**CIRCULAR LETTER
NUMBER 35-2007**

ROTAX
NEW AGE KARTING

MAX CRANK CASE

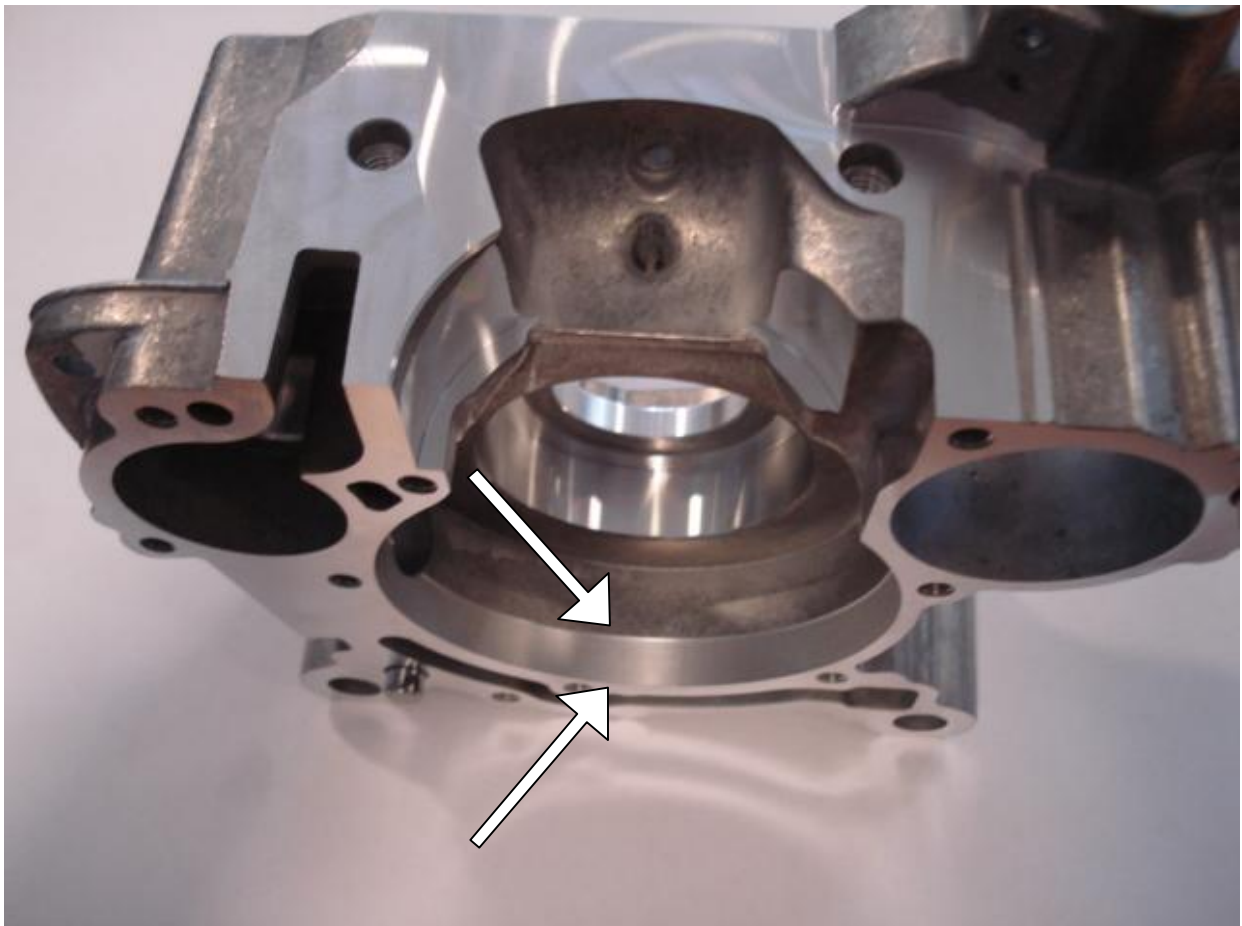
enclosed we would like to introduce you a technical change on the 125 MAX/Junior MAX engine.

We had some problems in the past where the conrod was contacting the crankcase. That's why we had to do a control machining on both halves of the crankcase. See picture below.

The maximum diameter of the clearance bore is $\varnothing 92.50\text{mm}$.

The maximum depth of the clearance is on the crank case pick up side 10.80mm.
The maximum depth of the clearance is on the crank case clutch side 8.80mm.

Those machined crank cases are of course legal in the ROTAX MOJO MAX CHALLENGE races.
